MASTER DEVELOPMENT PLAN

CARMONA HILLS

Re: Carmona Hills **MDP # 049-06**

The City Staff Development Review Committee has reviewed the Carmona Hills Master Development Plan **M.D.P. # 049-06**. Please find enclosed a signed copy for your files. Your plan was approved for acceptance; however please note the following conditions:

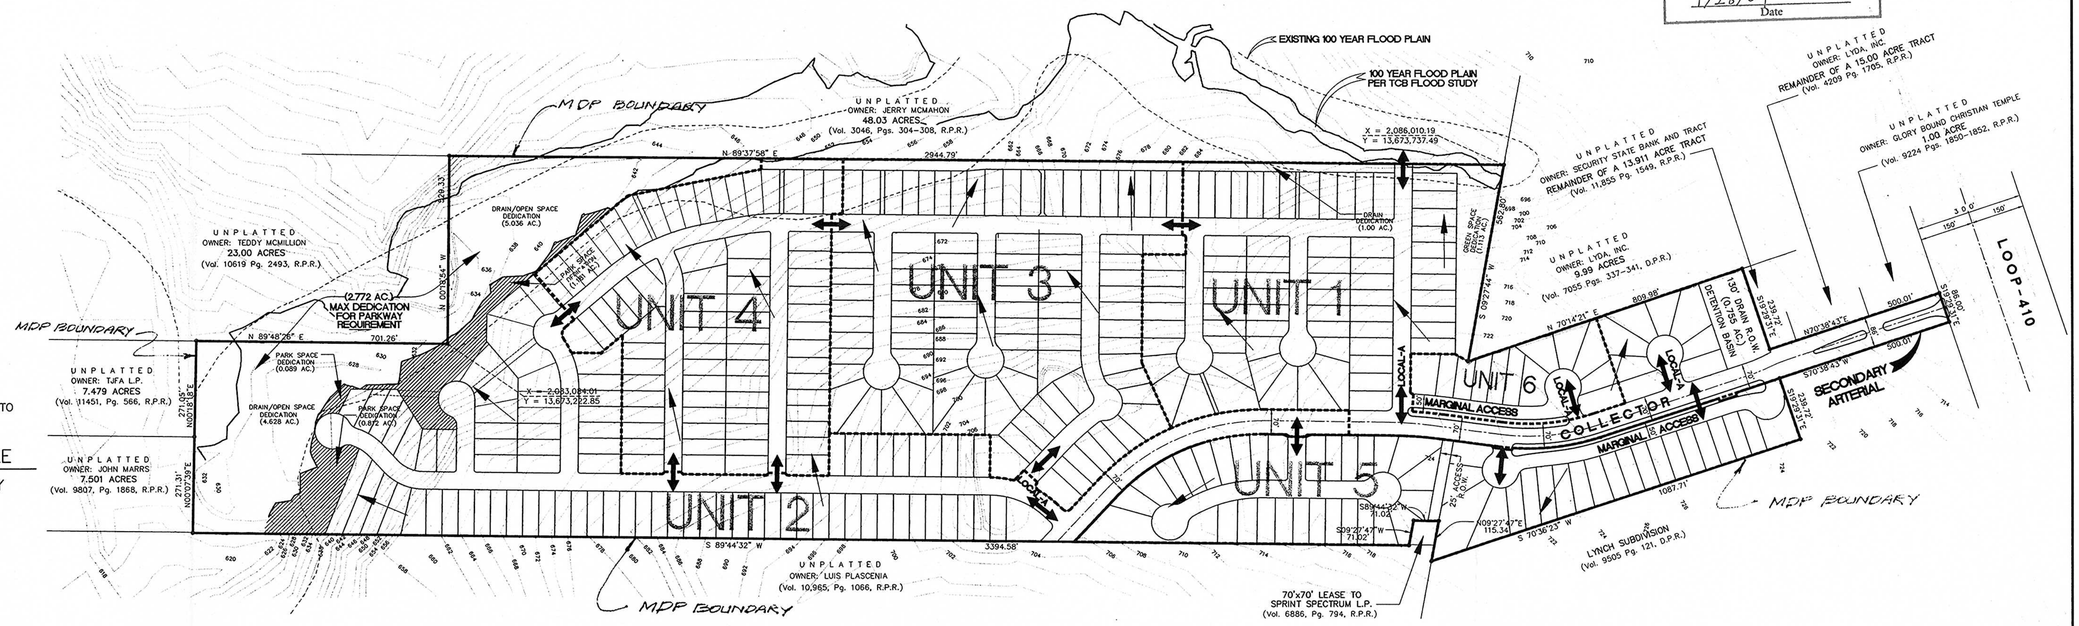
In consideration of public safety and convenience, excessive grades by reason of topography should be avoided in street layouts and arrangements. Any access and R.O.W. issues along state facilities will need to be resolved with the **Texas Department of Transportation (TXDOT)**. For information about these requirements you can contact TXDOT at 615-5814.

- All access driveways shall comply with UDC 35-506 (r).
- All roadways shall conform to Table 506-2 Functional Classification System Description for Traditional Design Classification.
- All sidewalks shall comply with UDC 35-506 (q).
- All access roadways shall provide clear sight distance on all existing and proposed roadways in order to provide adequate obstruction free viewing distances fro approaching traffic. All signage, landscaping, and improvements shall be selected and located so as to not block these clear sight distances areas.
- A right turn deceleration will be required to be installed as per TxDot requirements.

- The parkland provided shall be shown as "Park" or "Open Space" on a plat; UDC section 35-503(e) *Designation of Parkland.*
- The parkland provided is dedicated to the Homeowners Association.
- The instruments creating the Homeowners Association are provided by the second application for plat approval; UDC section 35-503(e) *Designation of Parkland.*
- Parkland dedication shall be platted by the second phase of residential development; UDC section 35-503 (f) *Development Phasing.*
- All amenities provided shall comply with standards and specifications found in UDC section 35-503(h) *Credit Park Facilities* and Table 503-4 if any credit is to be awarded.

- 2003 Tree Preservation ordinance standards per UDC Section 35-523 – a Master Tree Permit (AP 1301746) has been issued for this project using the Tree Canopy Method – no removal permitted in flood plain and plan indicates 45% preservation on site. A $75 fee will be charged at platting for follow-up inspections.
- Streetscape standards per UDC Section 35-512 – The Secondary Arterial and Collector streets to be constructed require streetscape trees. Estimates of planting costs and plan and profiles for streetscape will be required at platting stage.
